# **Applicant's Response to Stop Lime Down Written Representations – Appendix D Transport Report**

**Planning Inspectorate Reference: EN010168**

**Document Reference: EXAM/9.34**

**Plate 2-1 50 x 50 Compound Layout**

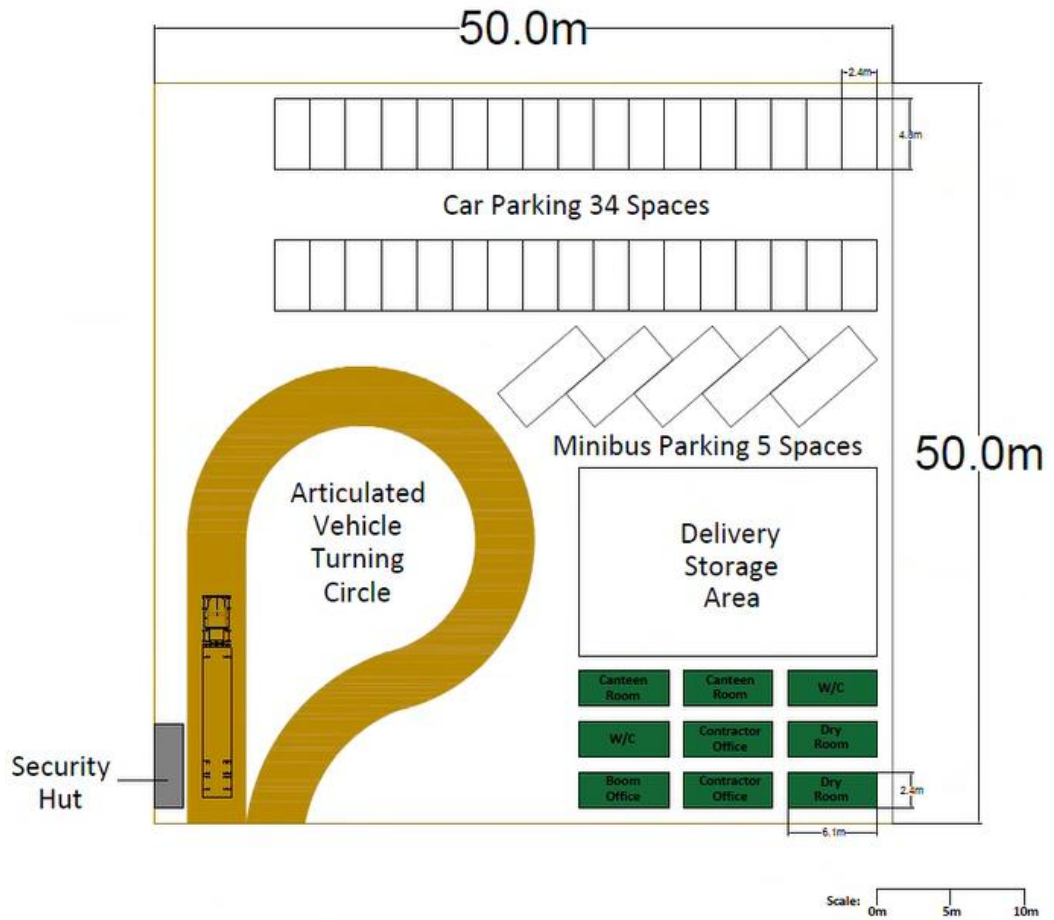
2.1.20 Paragraph 2.9 bullet point 10 states:

*“The allowance that has been made for the construction and removal of compounds would imply that the compounds were less than 50m x 50m. This is very unlikely to be feasible;”*

An example of a 50m x 50m Temporary Construction Compound Layout is shown in Plate 2-1 below. There are multiple compounds in some parcels.

The below summarises the number of compounds per parcel along with worker trips. It clearly shows enough capacity to cater for the number of workers and corresponding vehicles set out in **Table 1**. Compound aggregate can also be reused for where other aggregate is required elsewhere.
